Planning and Zoning Board Agenda February 12, 2019

- C. Site Plan - San Felasco Hammock State Park Shop Building: A request by Michael Freidin of George & Associates, Consulting Engineers, Inc., applicant and agent for the State of Florida, property owner, for consideration of a Site Plan for the construction of a ±2,030 square foot shop building on a ±.33 acre project area on a ±300 acre subject property. Tax Parcel No. 04033-000-000 (Quasi-Judicial)

- D. Upland Industrial Park, Lots 2 - 5 Site Plan: A request by Daniel Young, P.E., LEED A.P., of Causseaux, Hewett, & Walpole, Inc., applicant and agent for Upland Properties of NCF, LLC, property owner, for consideration of a Site Plan for the construction of two (2) buildings, a ±23,439 square foot building and a ±26,682 square foot building, with associated drainage, paving, grading and infrastructure improvements, on a ±4.82 acre subject property, located on Lots 2 – 5 of Upland Industrial Park and at the terminus of NW 101st Drive; Tax Parcel Nos. 05964-002-002 through 05964-002-005 (Quasi-Judicial Hearing).

A310
ARCHITECTURAL
DUMPSTER
ENCLOSURE DETAILS

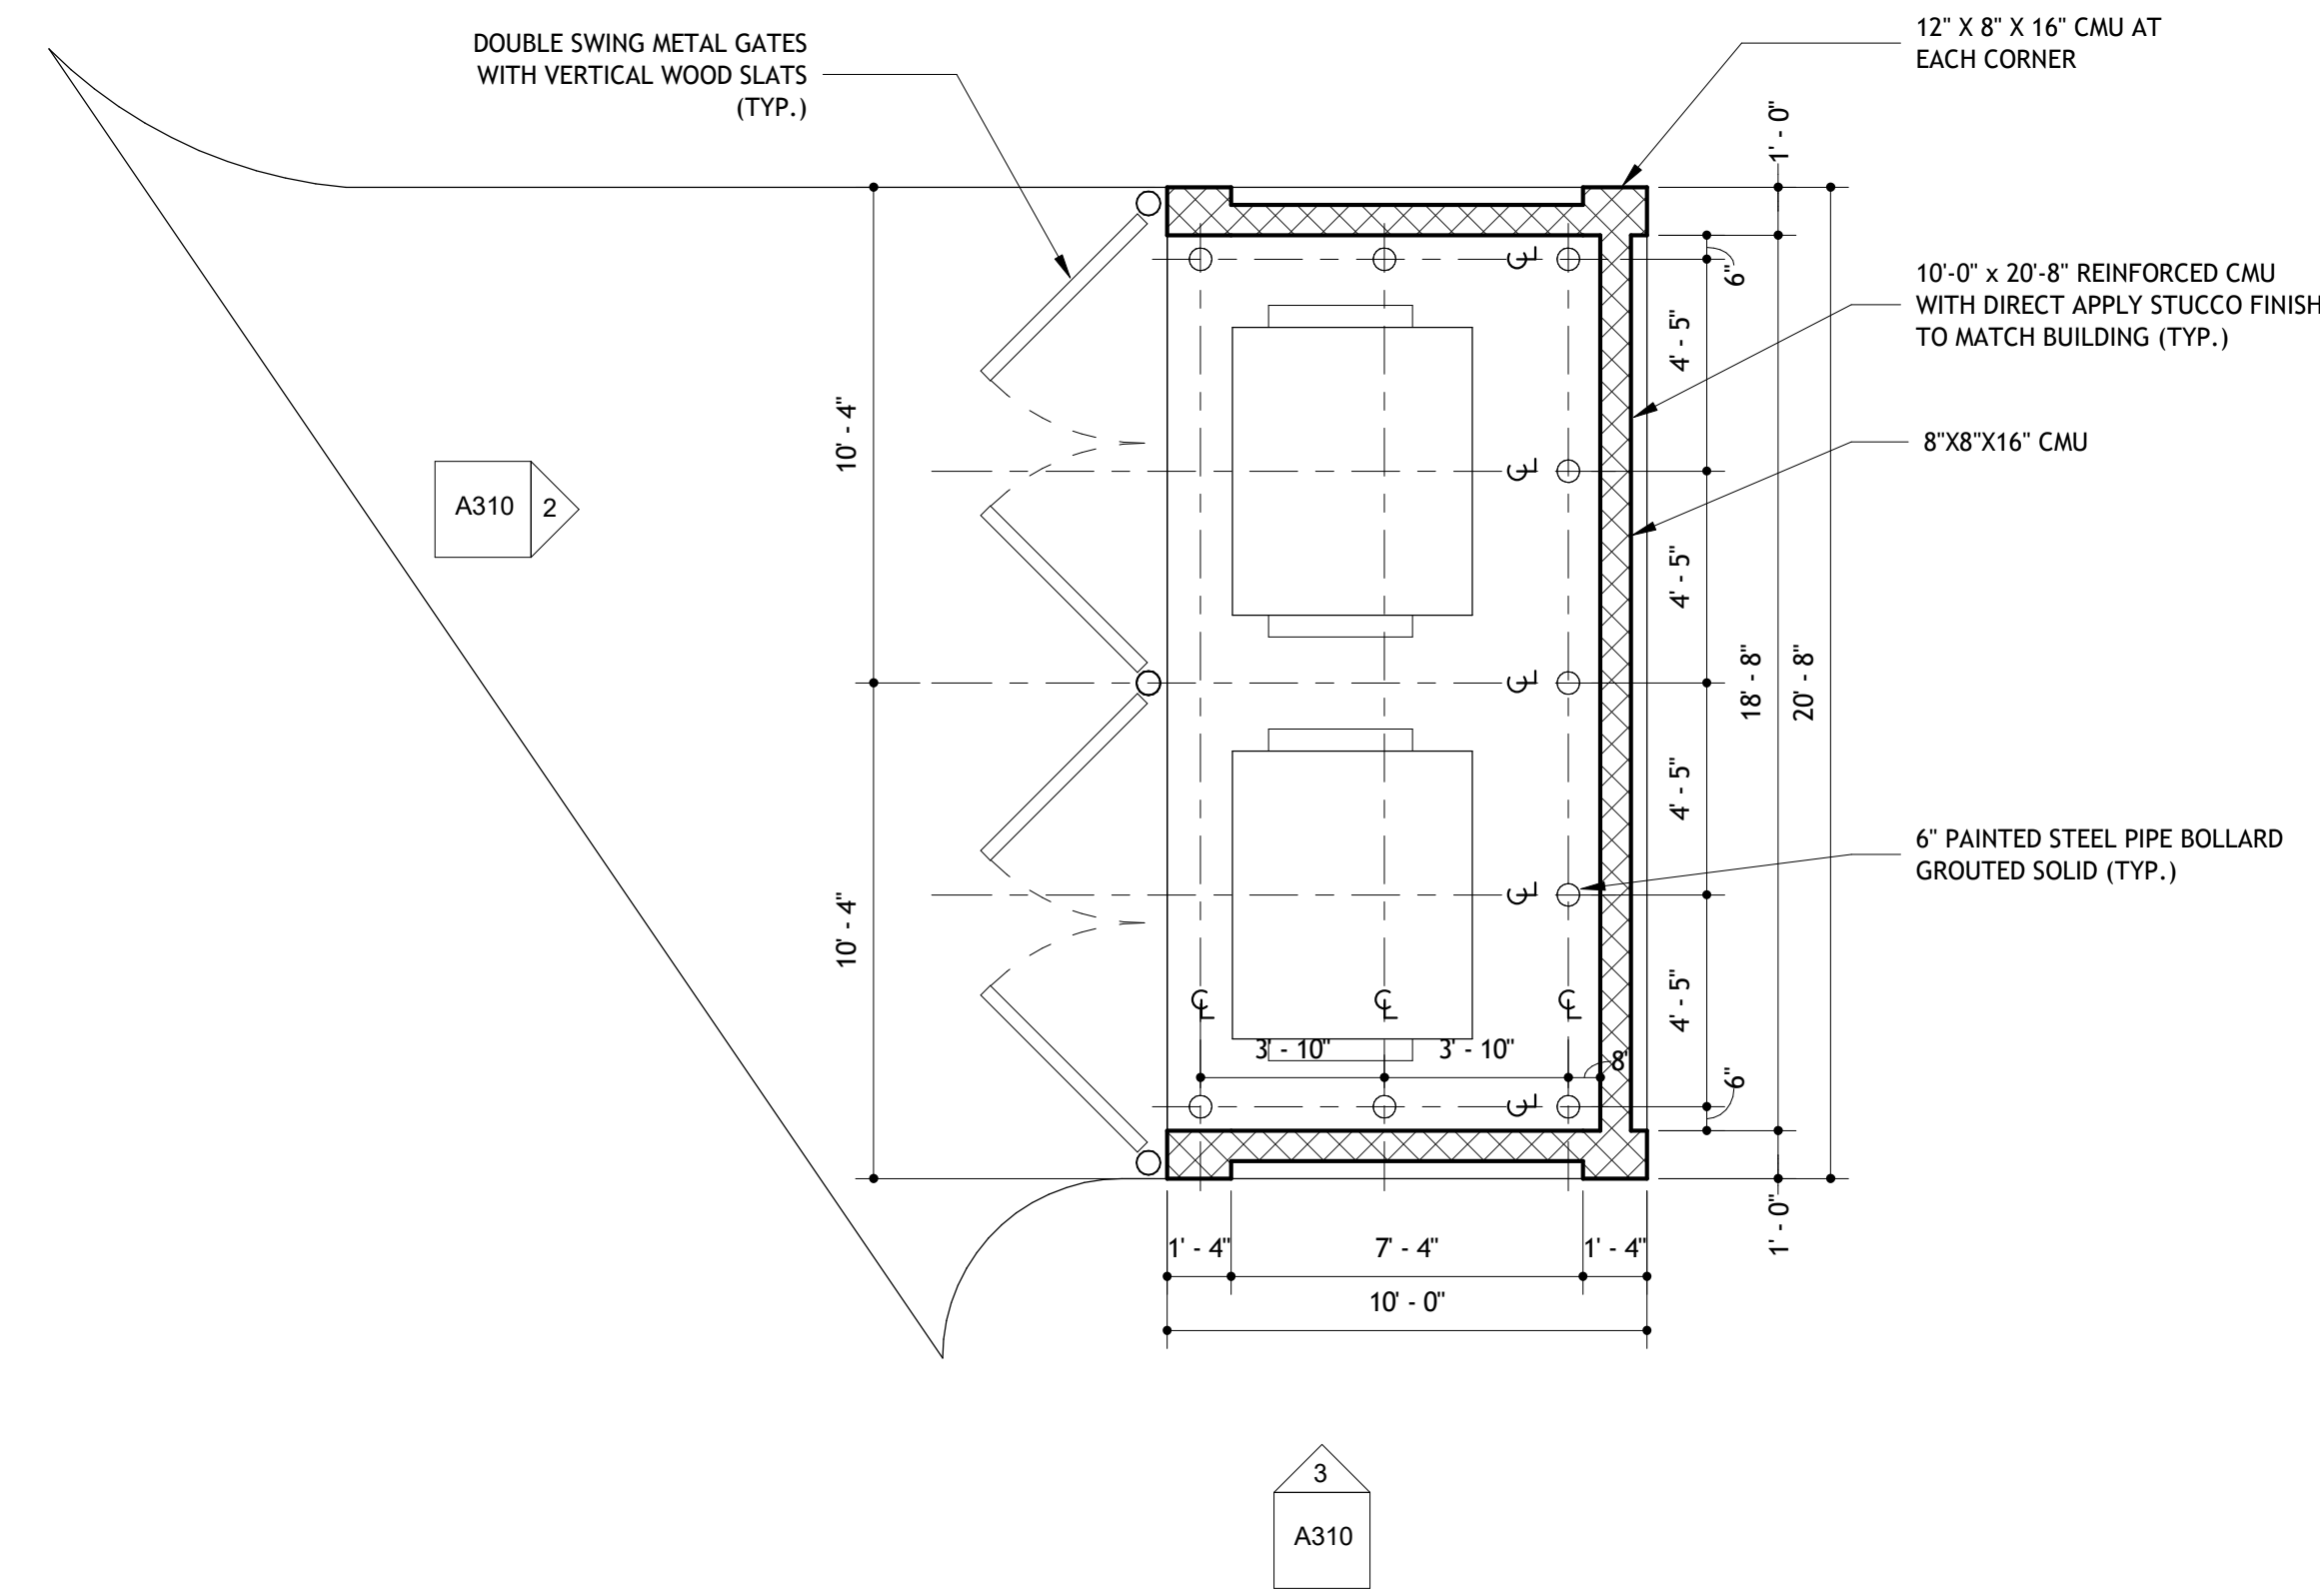
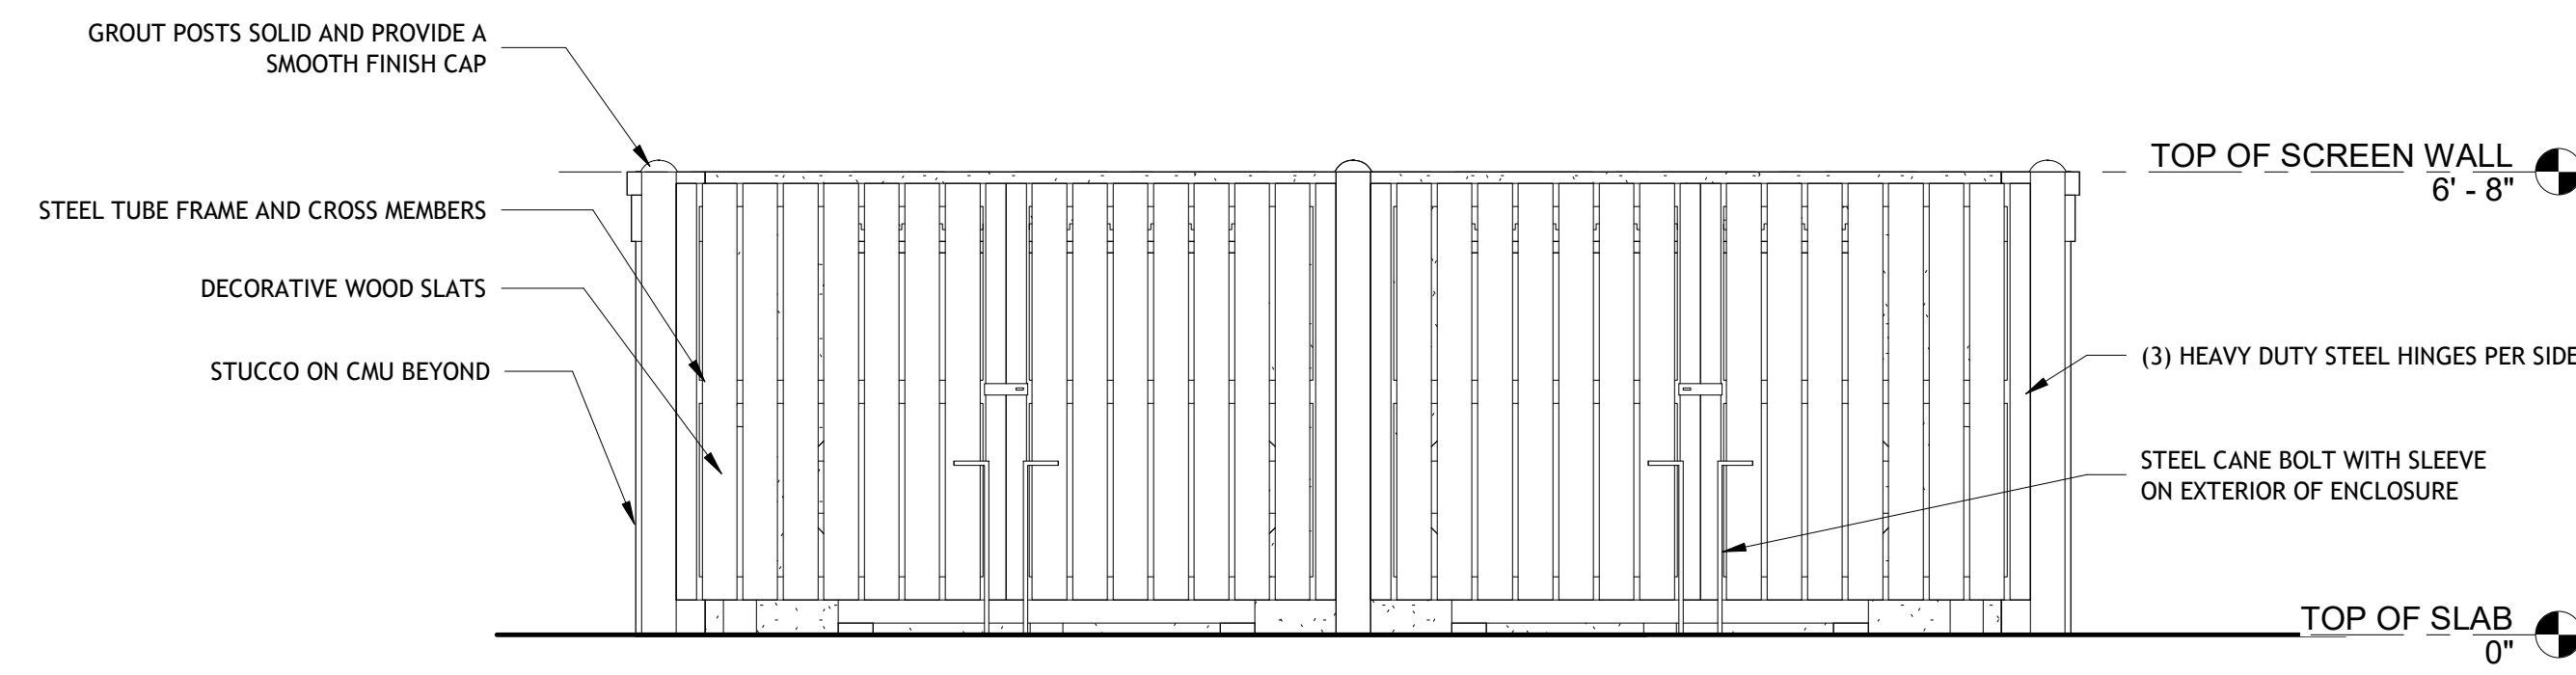
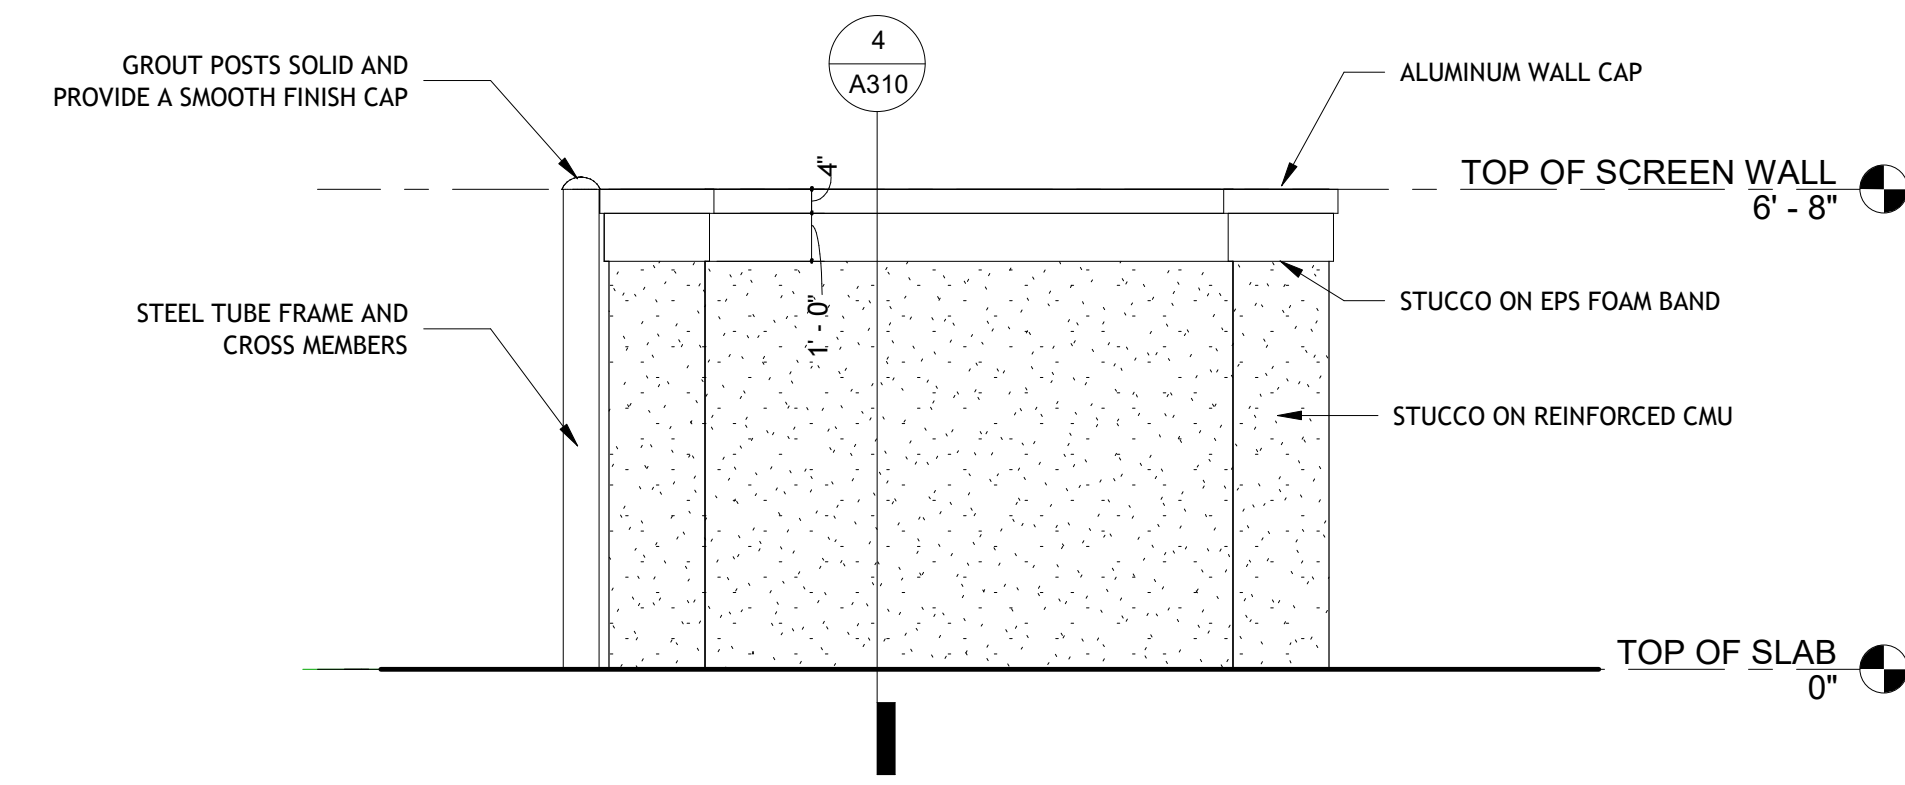
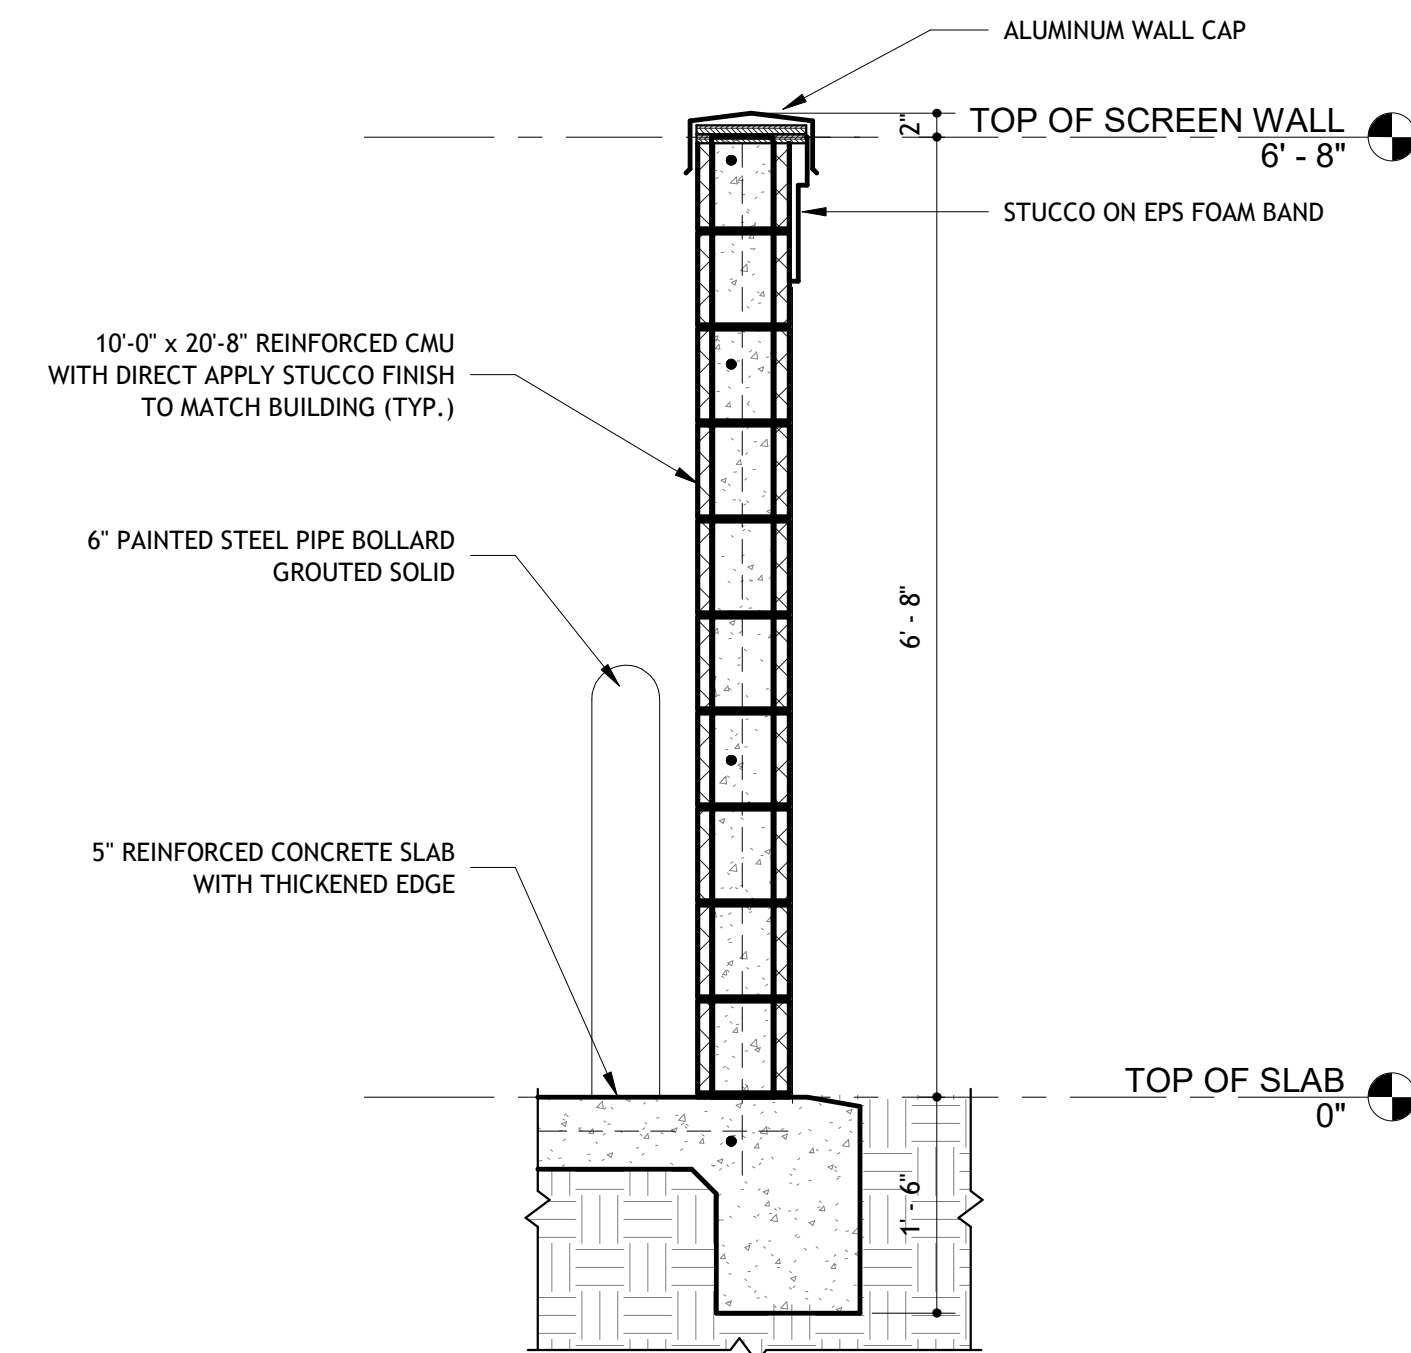
Remaining Issues: Comment was not addressed. Sheet A310 still states "decorative vertical wood slats or chain link with vertical vinyl slats". Revise accordingly.

Remaining Issues: Comment was not addressed. Sheet A310 still states "*decorative wood slats or chain link with vinyl slats*". Revise accordingly.
